Date: November 15, 2007
To: T10 Technical Committee
From: Alvin Cox (alvin.cox@seagate.com)
Subject: SAS-2 6Gbps PHY Electrical Specification

Abstract: The attached information defines the electrical requirements for 6 Gbps transmitter devices, receiver devices, and TxRx connection.

Figure xxx —6Gbps RTTL physical characterization

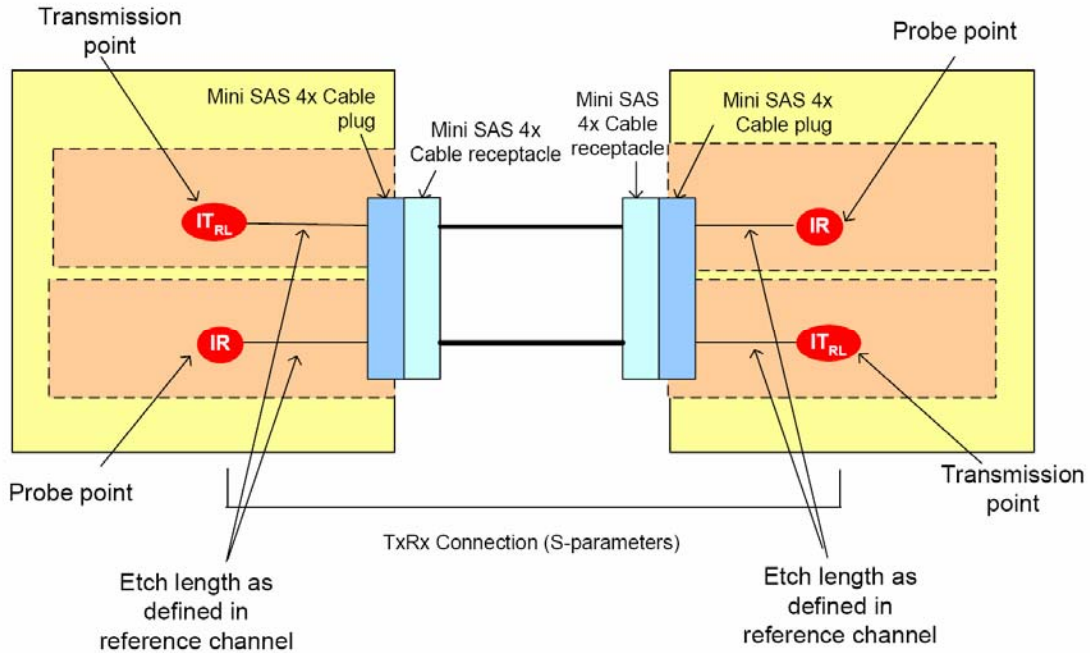
For 6 Gbps simulation testing, the reference transmitter test load (RTTL) is described by the S-Parameter (S4P, Touchstone format) model available from the T10 web site, proposal 07-193, SAS 2.0 Transmitter Test Load. The physical model used to measure the RTTL is illustrated in

Figure xxx. The etches between the transmission points and probe points are typically included in any TxRx connection S-Parameter measurement and the specific etch configuration for the RTTL is defined in the SAS 2.0 Transmitter Test Load documentation. Although these etches add extra loss to the TxRx connection, they are considered to be an acceptable amount of loss for simulation purposes when restricted to a configuration similar to the RTTL.

The RTTL information is used with simulation methodology to determine transmitter delivered signal compliance at the equivalent probe points located after the reference receiver device applies DFE (see 5.3.7.4.3). The specific simulation program used is beyond the scope of this specification. An example simulation file used with StatEye (www.stateye.org) is available as proposal 07-227, SAS-2 10m Cable Results (Stateye Analysis). This simulation file includes the reference transmitter device (see 5.3.6.5.4), RTTL, and reference receiver device parameters already entered into the file to help develop the simulation process.

Figure 105 — Example 6Gbps TxRx connection compliance testing

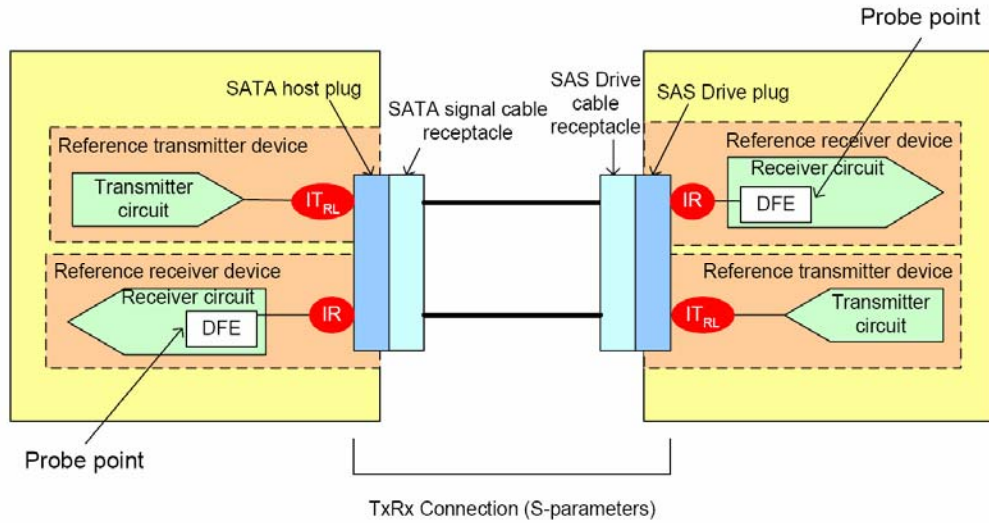
For 6 Gbps applications, the TxRx connection shall support a bit error ratio (BER) that is less than 10^{-15} (i.e., fewer than one bit error per 10^{15} bits) **based on digital communication link simulation results**, with data input from S-parameter measurements of the TxRx connection, the specified reference transmitter device, and the specified reference receiver device. **Figure 105 illustrates an example circuit for simulation.** The specific simulation program used is beyond the scope of this specification. Simulations typically do not include all aspects of noise that may degrade the received signal quality. The support of a BER that is less than 10^{-15} by simulation should yield an actual BER that is less than 10^{-12} . For external Mini SAS 4x cable assemblies, these electrical

SAS 6 Gbps transceiver devices incorporate enhanced features to allow them to operate over high-loss TxRx connections. These high-loss TxRx connections may not be suitable for use with phys compliant with previous versions of this standard or for 6 Gbps SATA devices.

Figure 118 — Transmitter device common mode voltage limit

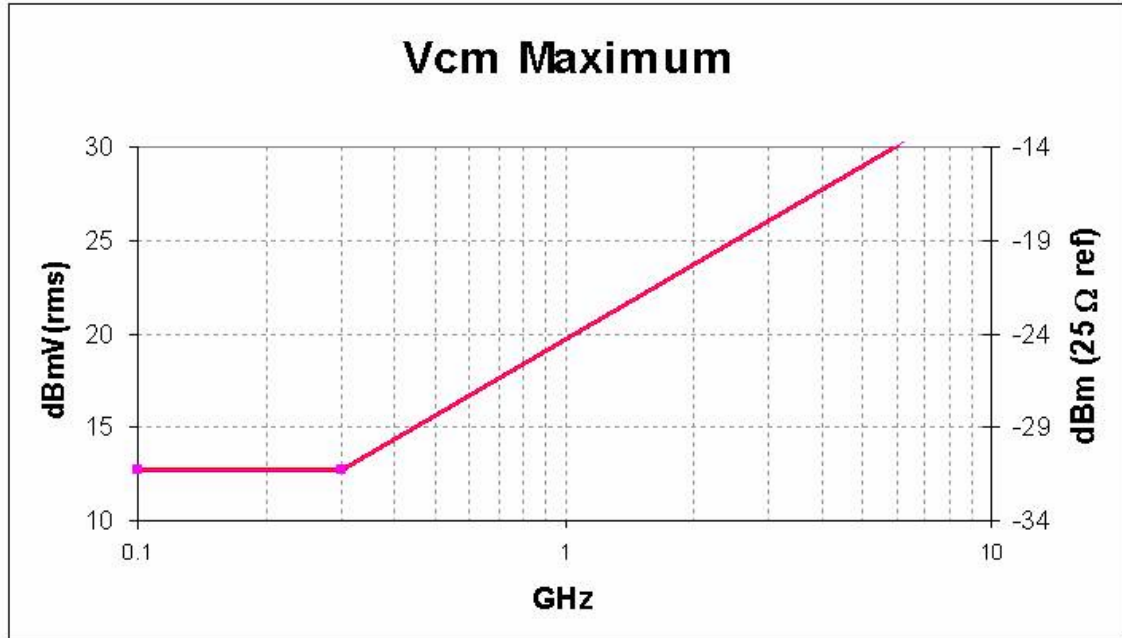
d Broadband (total) rms Common Mode Voltage limit. For additional limits on spectral content, see Figure 118 and Table yyy.

Figure 119 — Return loss variables

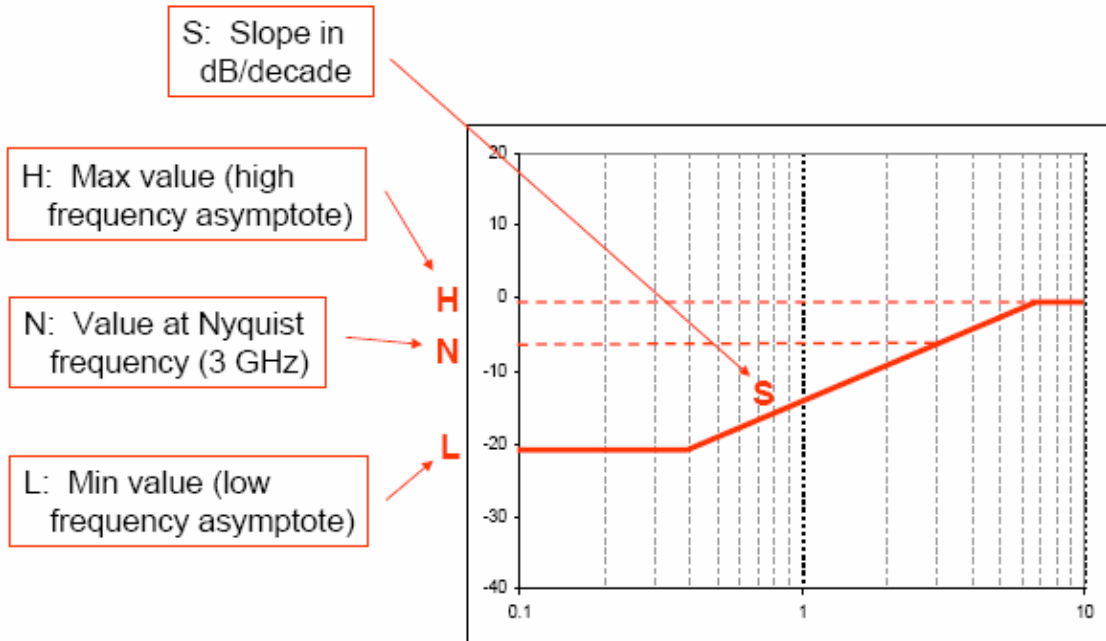
Return loss limits shall be calculated per the following formula. Variables are illustrated in Figure 119 and specified in Table 63.

$$\text{Measured Value} < \max [L, \min [H, N + 13,3 \log_{10}(F/3\text{GHz})]]$$

Figure 122 — Transmitter equalization measurement

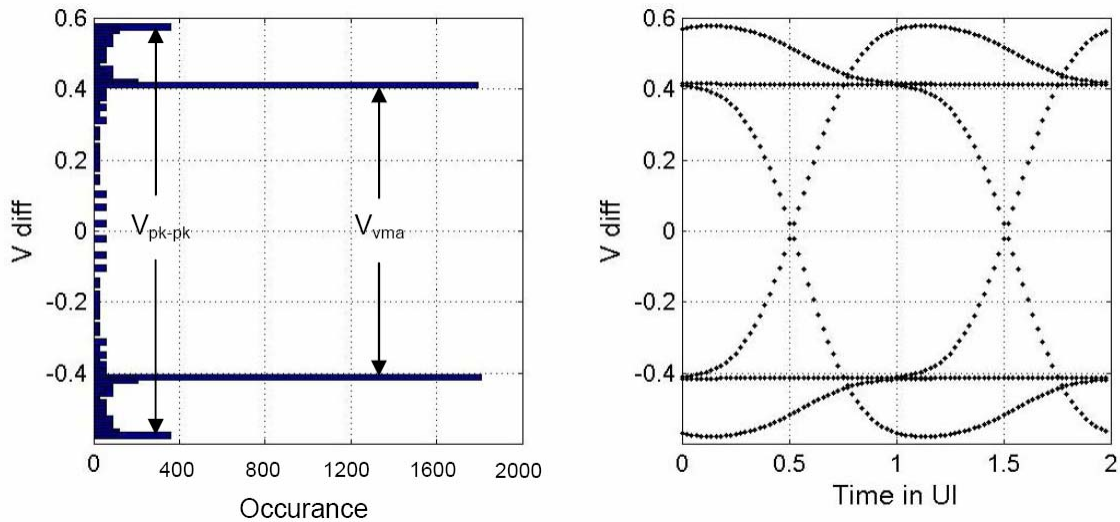
- c. The V_{vma} mode value and V_{pk-pk} peak value shall be determined as illustrated in Figure 122. A sample size of 1 000 minimum, 2 000 maximum histogram hits for V_{vma} shall be used to determine the values. The histogram in the figure is a combination of two histograms, an upper histogram for TX+ and lower histogram for TX-. (The histograms on the left of the test pattern signal displayed on the right.) The V_{vma} mode value and V_{pk-pk} peak value are determined by adding the values measured for TX+ and TX-.

4. The following formula shall be used to calculate the equalization value:
